**Project
T10/1683-D**

Revision 13
27 September 2007

**Information technology -
SCSI Architecture Model - 4 (SAM-4)**

Summary of Comments on SCSI Architecture Model - 4

Figure 1 — Requirements precedence

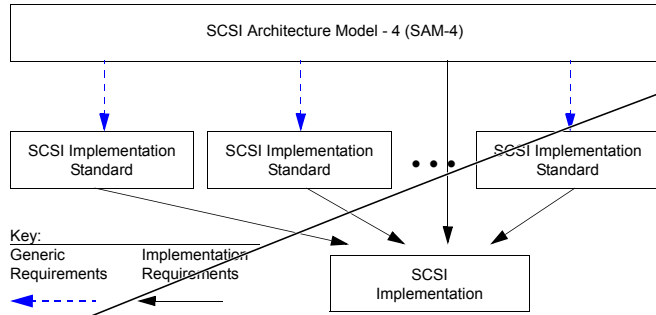
Since text takes precedence in this standard, and text should introduce figures, tables, etc., I recommend moving the following paragraph above figure 1.
- Status: George Penokie Accepted 10/26/2007 2:31:33 PM -05'00'

Figure 2 — SCSI document structure

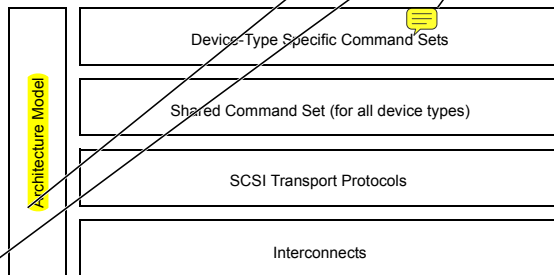
I recommend that at least one "e.g." be added either in the four rows in figure 2, in the descriptive text that follows, or both. See SBC-3 for an example.
- Status: George Penokie Rejected 10/29/2007 4:06:27 PM -05'00'

Emulex-001
Page: 2 first sentence below Figure 2 - "roadmap" s/b "document structure"
- Status: George Penokie Accepted 10/30/2007 2:17:02 PM -05'00'

Copied the SBC-3 figure into SAM-4.
- Author: relliott Subject: Highlight Date: 10/28/2007 10:45:42 PM -05'00'

Figure 8 — Object diagram conventions

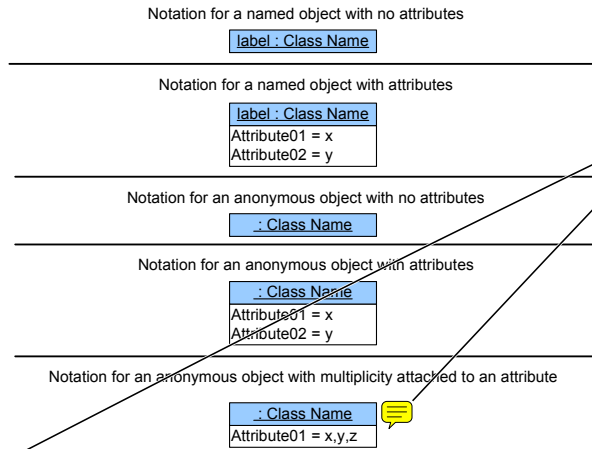
Author: George Penokie Subject: Note Date: 10/29/2007 3:30:04 PM -05'00'
 Having multiple values for an attribute is not valid for an instance of a class. It has been deleted from the figure. Note this change was also made to the style guide.

Figure 12 — SCSI client-server model

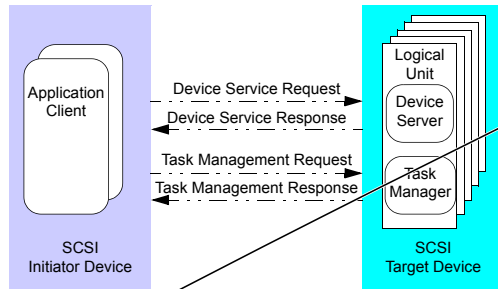
The last paragraph in 4.3.1 discusses commands and device server requests. It should also discuss TMFs and task management requests, to cover everything shown in figure 12.
- Author: George Penokie Subject: Note Date: 12/14/2007 10:55:26 AM

Figure 19 — SCSI Initiator Device class diagram

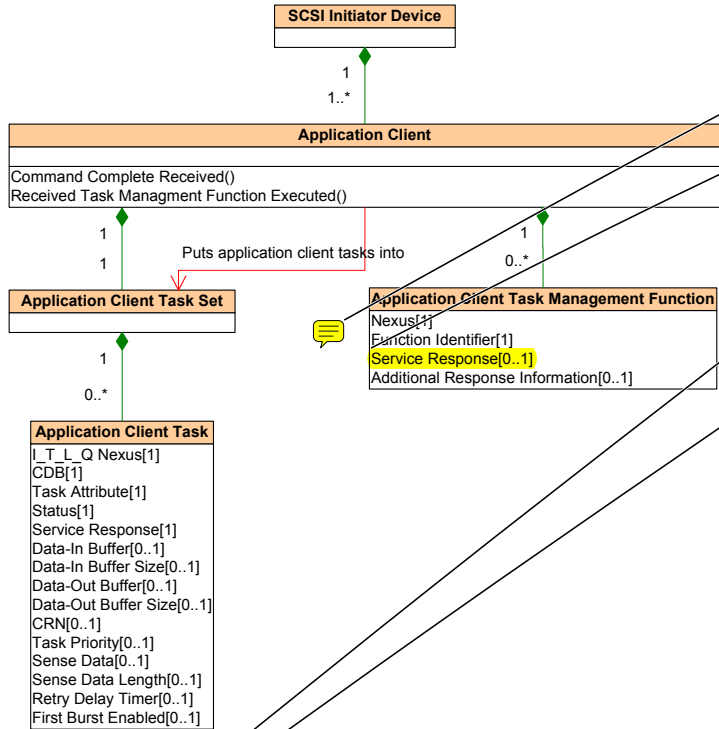
Author: reilott Subject: Note Date: 10/8/2007 6:53:04 PM -05'00'
 Nexus and Function Identifier should be swapped in figure 19 and in sections 4.5.11.2 and 4.5.11.3 to match the SCSI Target Device side in figure 22 and following sections. (or the target side should be swapped to follow this)

Figure 22 — Logical Unit class diagram

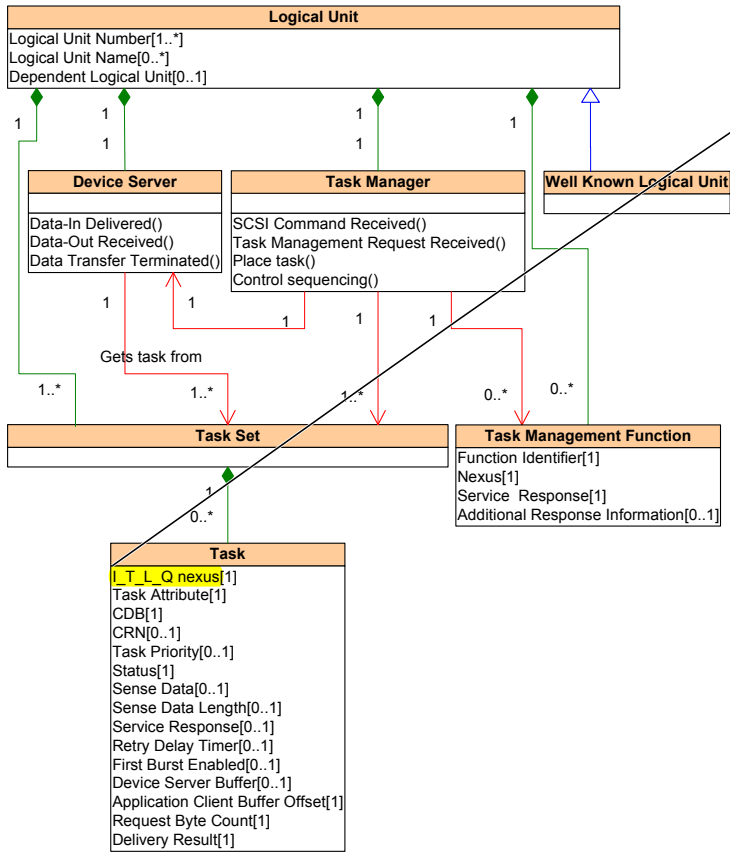
There is no class with that name, and it doesn't appear in figure 22.

Author: relliott	Subject: Highlight	Date: 10/8/2007 6:46:29 PM -05'00'
4.5.24.3 should be swapped with 4.5.24.2 to match the order the attributes are listed in figure 22.		
Status	George Penokie Accepted	10/30/2007 5:11:35 PM -05'00'
Author: sublerp	Subject: Sticky Note	Date: 10/25/2007 6:21:35 PM -05'00'
Should this say "receives a task or a task management function specifying a W-LUN" ?		
Status	George Penokie Accepted	10/30/2007 5:13:52 PM -05'00'
Author: George Penokie	Subject: Note	Date: 10/30/2007 5:13:49 PM -05'00'
Yes		
Author: relliott	Subject: Highlight	Date: 10/29/2007 11:16:28 AM -05'00'
selection of incorrect logical units s/b incorrect logical unit numbers		
Status	George Penokie Completed	12/26/2007 11:07:34 AM
Author: George Penokie	Subject: Note	Date: 12/26/2007 11:16:12 AM
Changed to << addressing an incorrect logical unit >> Changed globally. Also, changed all << incorrect LUN >> to << incorrect logical unit number >>.

Status
George Penokie Accepted 10/30/2007 5:05:22 PM -05'00'
Author: George Penokie Subject: Note Date: 10/30/2007 5:05:06 PM -05'00'
Deleted the entry as it was a hold over from a previous version of the UML.
